Access Compliance Report Public Rights-of-Way (Curb Ramps)

Main Street: E_ORANGE_GROVE_AVE Cross Street: HEWES_ST Location: SE

ADA ID: RPAT211020084908 Ramp Type: Type 1 - Perpendicular Diagonal Initial Pass/Fail: Fail Overall Compliance: No Severity Score: 2

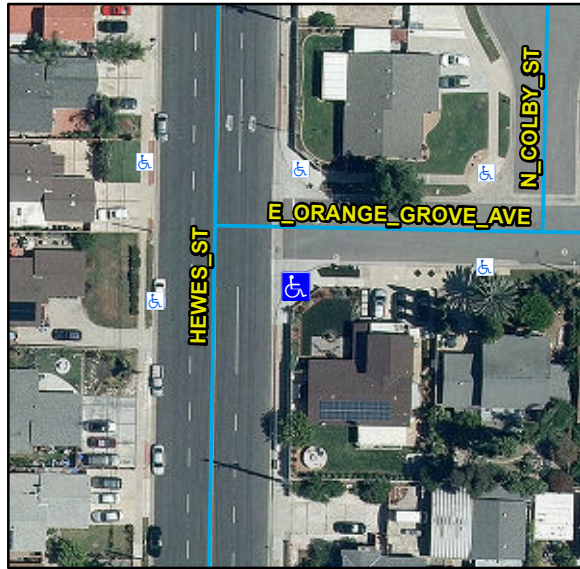
Compliance	Description	Data	Compliance	Description	Data
N/A	Ramp Length (in)	60	N/A	Flare Type LT	
Yes	Ramp Width (in)	48			N/A
Yes	Ramp Run Slope (%)	4.1	N/A	Flare Slope LT (%)	N/A
No	Ramp Cross Slope (%)	3.8	N/A	Flare Traversable LT	N/A
N/A	Landing Present	N/A	N/A	Flare Type RT	
N/A	Landing Length (in)	N/A			N/A
N/A	Landing Width (in)	N/A	N/A	Flare Slope RT (%)	N/A
N/A	Landing Run Slope (%)	N/A	N/A	Flare Traversable RT	N/A
N/A	Landing Cross Slope (%)	N/A	N/A	DWS Provided	N/A
N/A	Landing Movement Obstructed?	N/A	N/A	DWS Contrast	N/A
	Landing Movement Type	N/A	N/A	DWS Length (in)	N/A
N/A	Landing Shared	N/A	N/A	DWS Full Width	N/A
N/A	Clear Space	Yes	N/A	DWS Offset Left (in)	N/A
N/A	Clear Space To Crosswalk (in)	N/A	N/A	DWS Offset Right (in)	N/A
N/A	Marked Crosswalk 1	No	N/A	Marked Crosswalk 2	No
	Crossing 1 Direction	N		Crossing 2 Direction	W
	Marked Crosswalk 1 Width (in)	N/A		Marked Crosswalk 2 Width (in)	N/A

N/A	Ramp Inside Crosswalk 1	N/A	Yes	Ramp Inside Crosswalk 2	N/A
	Crossing 1 Slope (%)	1.8		Crossing 2 Slope (%)	6.9
	Crossing 1 Cross Slope (%)	3.2		Crossing 2 Cross Slope (%)	1.1
N/A	Gutter Ponding	N/A	No	Curb Slope	10.4
Yes	Gutter Lip Height (in)	0		Road Run Slope (%)	2.6
N/A	Gutter Run Slope (%)	N/A		Road Cross Slope (%)	2.7
N/A	Gutter Cross Slope (%)	N/A			
Yes	Overall Surface Condition: Acceptable		Yes	Perp Joint Present	Yes
	Cross Gutter Present?	Yes		Spandrel Present?	Yes
	Replace Cross Gutter?	No		Replace Spandrel?	No

Remove & Replace Curb Ramp With Two New Directional Ramps or Equivalent.
